Pressure Attenuators

AS/NZS 3500.2.2021 – Clause 6.11.3

Revision and Renewal of Venting Provisions 6.10 AAVs and 6.11 Pressure Attenuators of 3500 Part 2
2018

John McBride for Studor Australia

Installation of the P.A.P.A.™ Device

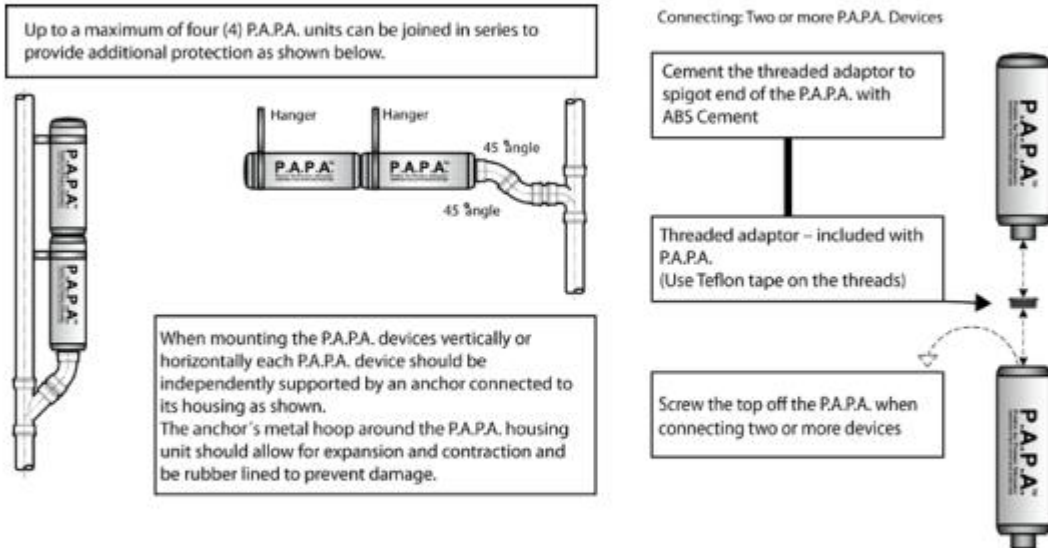
Note: The P.A.P.A. must be installed after the System's pressure test, in an accessible location.

Note: Accessible; in regard to the P.A.P.A. device is defined as noting the location of the P.A.P.A. device on the final plans for the building. The P.A.P.A. may be located behind the sheetrock wall or ceiling without an access panel. If the P.A.P.A. is located behind a concrete wall or block wall an access panel is required.
